## **Actions Needed To Increase The Safety Of Dams Built By The Bureau Of Reclamation And The Corps Of Engineers**

After reviewing procedures and practices used by the Bureau of Reclamation in constructing the Teton Dam which collapsed in 1976, GAO found that the Bureau

GED-77-85

JUNE 3, 1977

## EMBANKMENT EXPLANATION

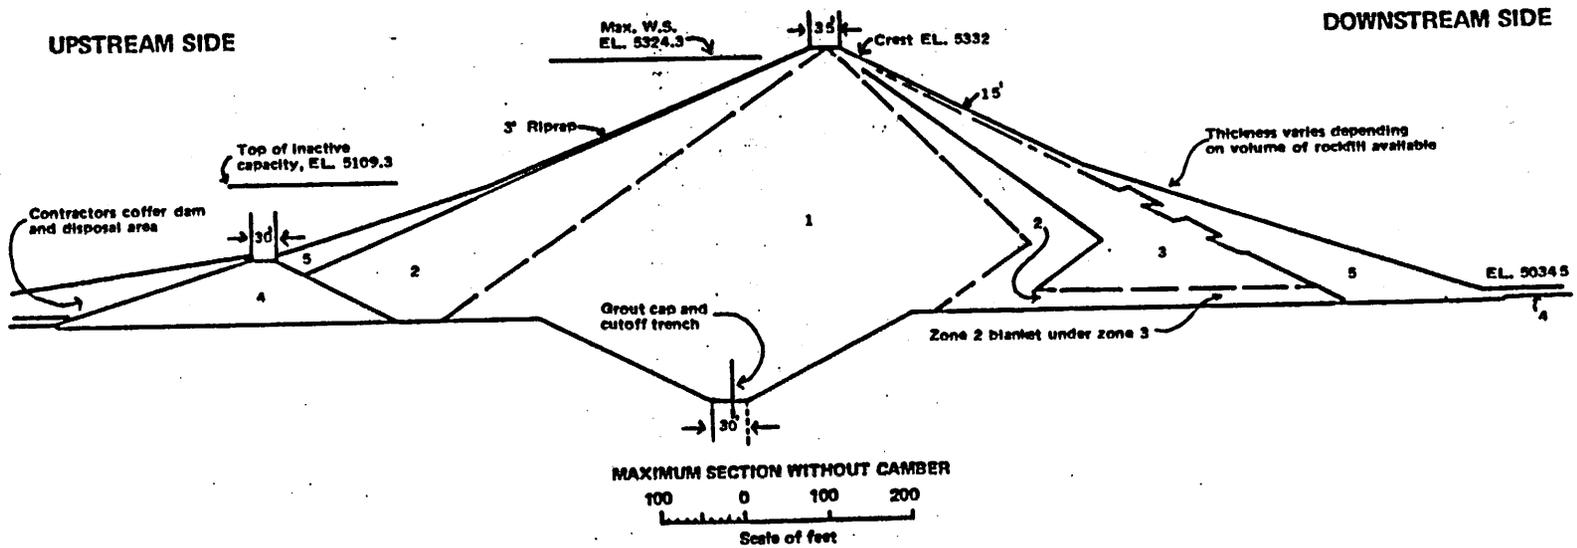
The Bureau relied on the Zone 2 material to collect seepage that would penetrate the impervious core and carry seepage safely out of the dam. (See p. 28.) However, the Independent Panel questioned whether this zone provided effective drainage because test results indicated that the

FOUNDATION KEY TRENCH  
CROSS SECTIONAL VIEW

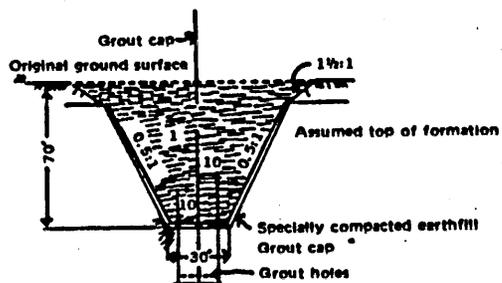
The Independent Panel also questioned the lack of a filter on the downstream side of the key trench. As previously described, the fine, highly erodible Zone 1 material was placed directly against the highly cracked rock. Thus, there were many places where seepage going through the key trench could escape and carry with it the fine grained Zone 1 material.

**GROUT CURTAIN**

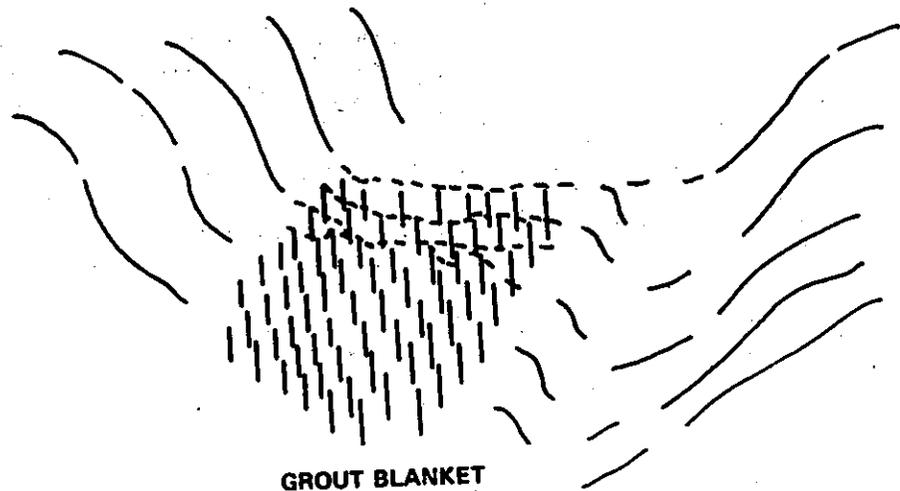
The grouting program at the Teton Dam was one of the most extensive efforts of its kind ever undertaken by the Bureau. The total program involved drilling 118,000 linear feet of holes and injecting nearly 600,000 cubic feet of cement, sand,

and other materials into the foundation at a cost of about \$4 million. Yet, the grout curtain may not have been effective in controlling seepage as intended. The Independent Panel concluded from its postfailure tests that water could pass through the grout curtain at several locations. Thus, it concluded that the grout curtain may not have been fully effective in controlling seepage in the critical key trench area. The Independent Panel questioned the adequacy of the design of the grout curtain as well as the heavy reliance placed on it to control seepage. In addition, there is a question whether additional measures should have been taken to test the adequacy of the grout curtain after it had been constructed.

Shape of the key trench and elimination of irregularities

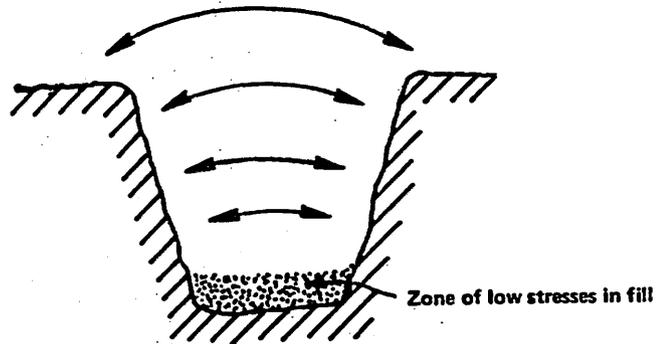
The Independent Panel concluded that poor compaction of the zone 1 silt material or cracks in the soil placed in the key trench could have contributed to the failure of the Teton Dam.

## EROSION DIAGRAMS

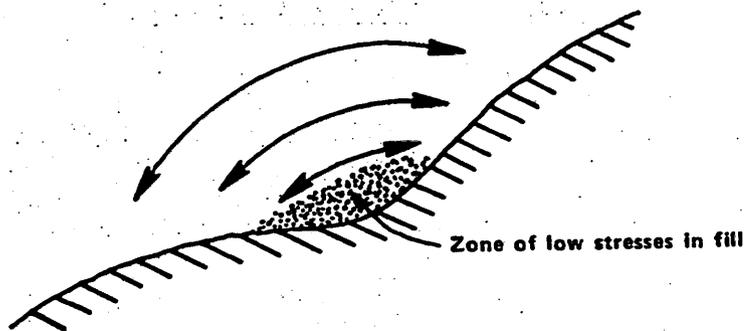
The Independent Panel said that the shape of the key trench, with its rigid rock walls and steep slopes, was favorable to the development of cracks through arching and hydraulic fracturing. Arching (see p. 37) prevents the full weight of the overlying embankment from bearing on the underlying material. If the arching effect reduces the pressure on the underlying materials sufficiently, water pressure can crack the soil by the process known as hydraulic fracturing. Based on observations, tests, and analyses, the Panel concluded that hydraulic fracturing of the soil in the key trench was a highly probable mechanism for the initial breaching of the key trench.

The Panel said that in the bottom of the key trench in the vicinity of the failure, there was a concentration of steps and overhanging rocks which made proper compaction of soil in the trench difficult and was conducive to arching as
